GE Critical Power CUSTOMER TECHNICAL SUPPORT CENTER PRODUCT CHANGE NOTIFICATION

Notification No: cn008206 Date: 8-1-2014

Product Type: DC-DC Converter (Standard Product)

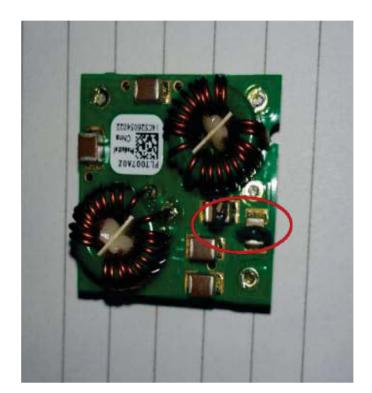
Isolation capacitors C4 and C5 are being replaced with C1210X472K152TZ. This is the same part as the previous but it now has a coating on it to prevent arching. This coating now eliminates the need for additional foam on these capacitors. See Photo attached for area where foam will be removed.
